ADDENDUM A
Staff Report: Z-69-20-6
November 3, 2021

<u>Camelback East Village Planning Committee Meeting Date</u>	October 5, 2021
<u>Planning Commission Hearing Date</u>	November 4, 2021
Request From:	R-O (0.89 acres)
Request To:	PUD (0.89 acres)
Proposed Use	Multifamily residential
Location	Approximately 300 feet west of the northwest corner of 16th Street and Maryland Avenue
Owner	East Maryland, LLC
Applicant	AUTEM Development
Representative	William E. Lally, Esq., Tiffany & Bosco
Staff Recommendation	Approval, subject to stipulations

The purpose of this addendum is to revise the staff recommended stipulations to account for changes to the PUD development narrative, per the applicant's request.

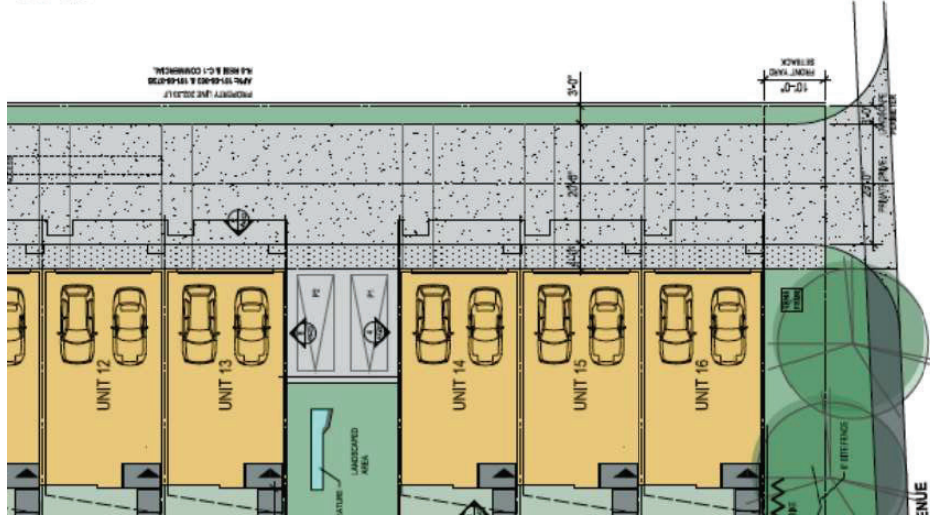
- 16 trash/recycling cans placed in the bike path starting the evening before collection and ending, potentially, the day after collection is unsightly and is a safety hazard
- The City ordinance states that collection bins be placed at the curb, not on the sidewalk **(Exhibit E)**
- No other multifamily housing developments with access to Maryland require residents to place trash/recycling on the street or on the sidewalk
- Megan Sheets, Project Manager for the Public Works Department offered 2 solutions to individual trash collection bins:

Variance for trash/recycling enclose in the landscape setback

Technical appeal to allow collection truck to back up more than 50 ft

EXHIBIT C

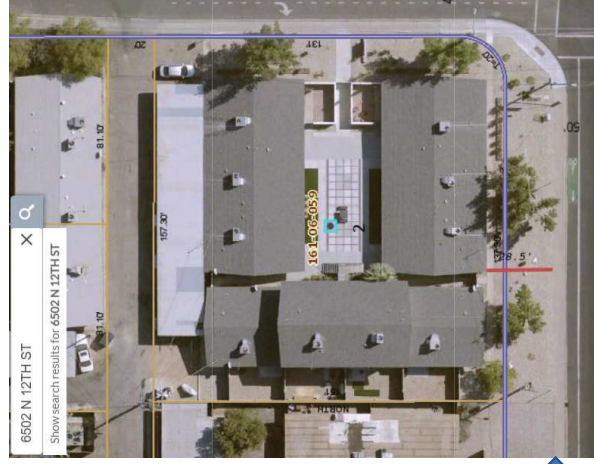
i. General comment: Staff is still not supportive of such a reduced setback (10 feet) along Maryland Avenue. Setbacks along this street average at 30 feet, with the closest building (to the east of the subject site) at 20 feet from the property line.

Response: The proposed setback is compatible with other properties along Maryland Ave. Specifically, the proposed development would be setback further than the buildings located at 6348 N. 13th St., Phoenix 85014 (APN: 161-12-205), 6502 N. 13th St., Phoenix 85014 (APN: 161-07-019); and 6502 N. 12th St., Phoenix, 85014 (APN: 161-06-059); therefore, the proposed setback mirrors the setback enjoyed by other developments in the area. Moreover, the proposed development features more advance architectural than the properties listed above; therefore, the impact to Maryland Avenue will not be as substantial. Additionally, there is a minimum of 6'-6" of further landscaped zone to the south of our property line before the sidewalk which provides additional buffer to the property from the street.

CITY OF PHOENIX PUBLIC WORKS DEPARTMENT SOLID WASTE ACCESS AND CONTAINMENT STANDARD DETAILS - SUPPLEMENT

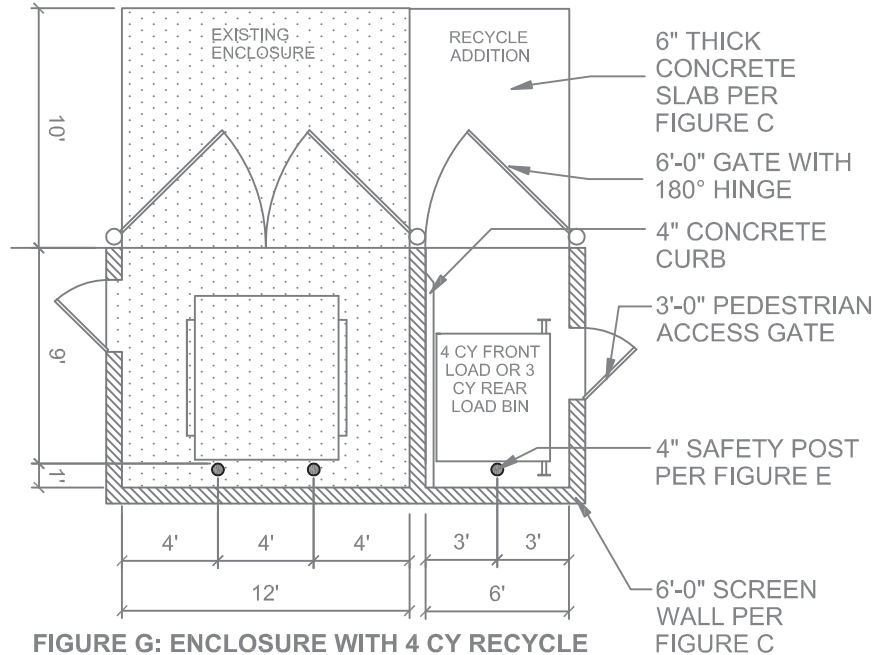
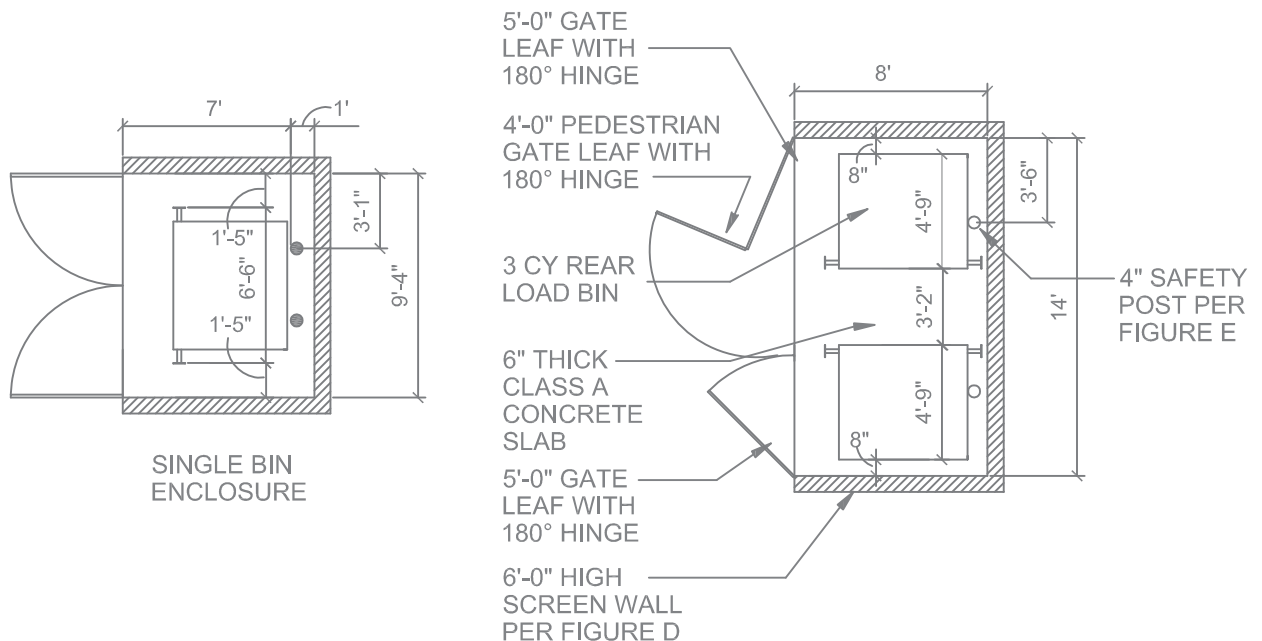
The site plan states the 16 townhome units will be lot sales, therefore the City will be collecting for both refuse and recycle. A centralized enclosure would make it a lot easier for each resident instead of wheeling a 90-gallon bin twice a week (one day refuse & another day recycle) to Maryland. Enclosures cannot be located in the landscape setback (without a variance) which makes it difficult to place towards the front where a truck could possibly collect and back up.

If you take the variance route, send me a revised site plan showing the enclosure location so I can approve. Sixteen units will require one 4 cy bin for refuse and one 4 cy bin for recycle. Attached is our infill enclosure that could be used for this community. See figure G.

EXHIBIT C

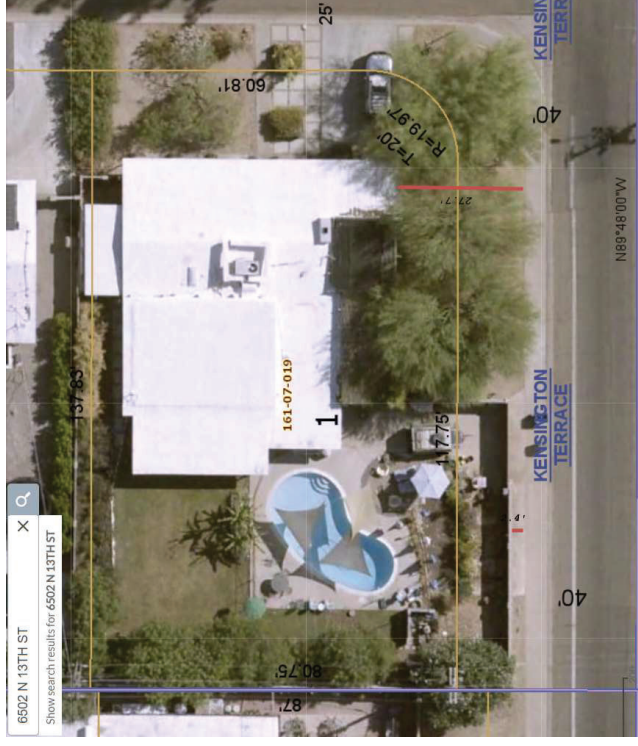
i. General comment: Staff is still not supportive of such a reduced setback (10 feet) along Maryland Avenue. Setbacks along this street average at 30 feet, with the closest building (to the east of the subject site) at 20 feet from the property line.

Response: The proposed setback is compatible with other properties along Maryland Ave. Specifically, the proposed development would be setback further than the buildings located at 6348 N. 13th St., Phoenix 85014 (APN: 161-12-205), 6502 N. 13th St., Phoenix 85014 (APN: 161-07-019); and 6502 N. 12th St., Phoenix, 85014 (APN: 161-06-059); therefore, the proposed setback mirrors the setback enjoyed by other developments in the area. Moreover, the proposed development features more advance architectural than the properties listed above; therefore, the impact to Maryland Avenue will not be as substantial. Additionally, there is a minimum of 6'-6" of further landscaped zone to the south of our property line before the sidewalk which provides additional buffer to the property from the street.

CITY OF PHOENIX PUBLIC WORKS DEPARTMENT SOLID WASTE ACCESS AND CONTAINMENT STANDARD DETAILS - SUPPLEMENT

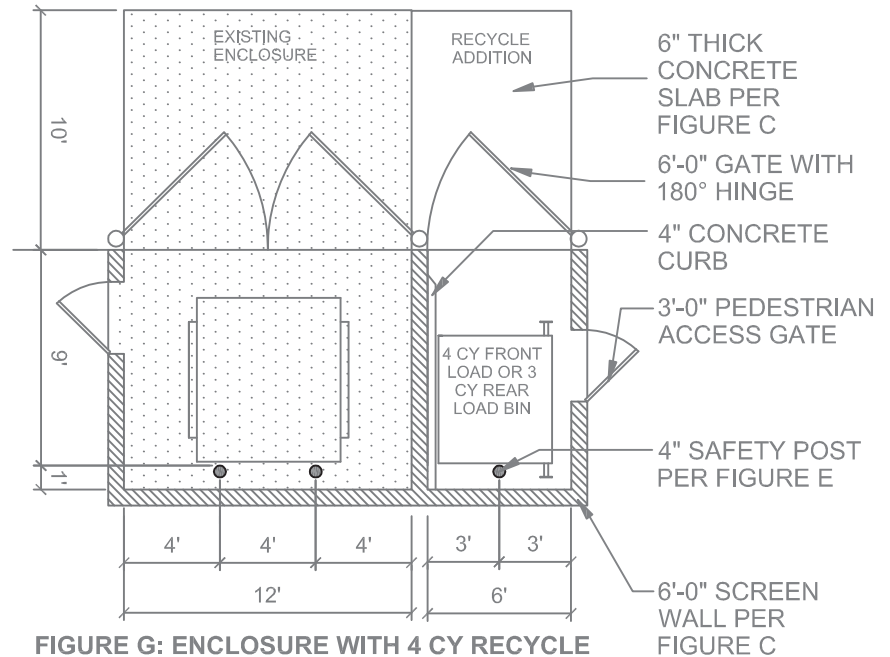
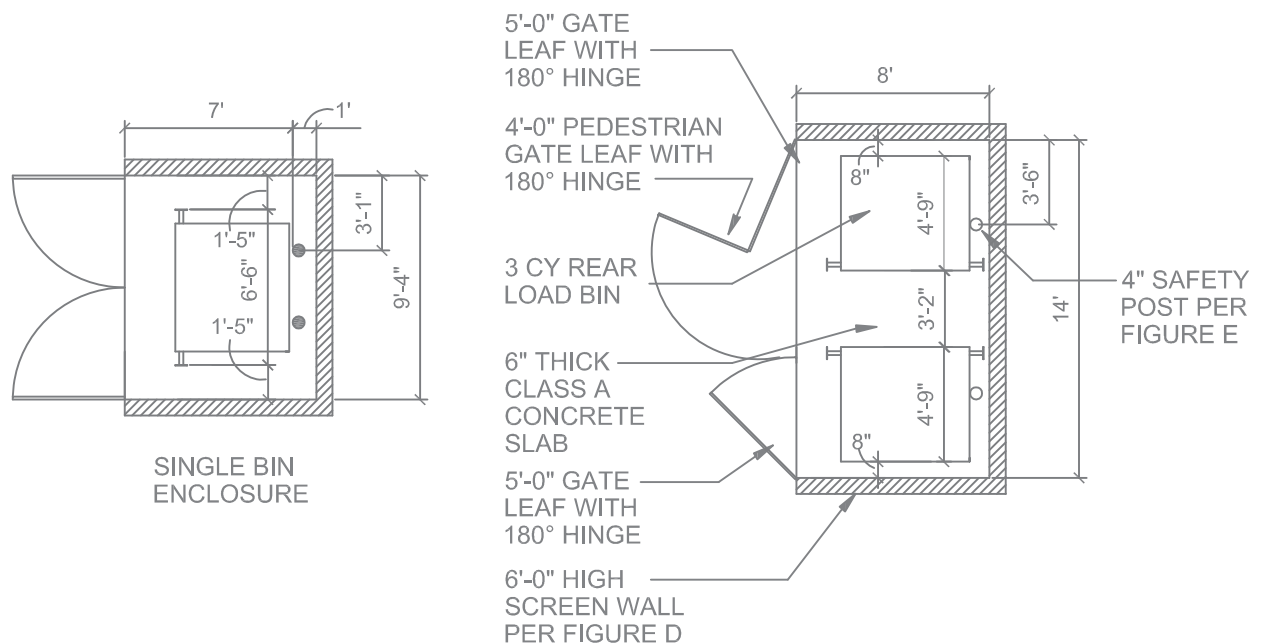
The site plan states the 16 townhome units will be lot sales, therefore the City will be collecting for both refuse and recycle. A centralized enclosure would make it a lot easier for each resident instead of wheeling a 90-gallon bin twice a week (one day refuse & another day recycle) to Maryland. Enclosures cannot be located in the landscape setback (without a variance) which makes it difficult to place towards the front where a truck could possibly collect and back up.

If you take the variance route, send me a revised site plan showing the enclosure location so I can approve. Sixteen units will require one 4 cy bin for refuse and one 4 cy bin for recycle. Attached is our infill enclosure that could be used for this community. See figure G.
